Product Change Notification (PCN)

PCN #: 4K-2025

Date: April 22nd, 2025

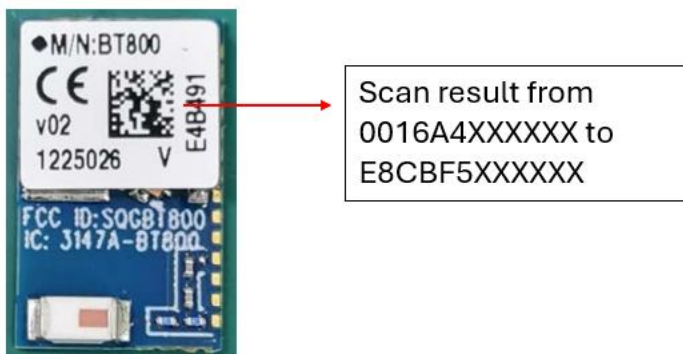
- Labeling of the devices utilizing the new OUI (E8CBF5) will change. The change is to replace the old OUI with the new one.

After this PCN, the module QR code scan result will have the E8CBF5 OUI. Take BT800 as the exemplary picture.
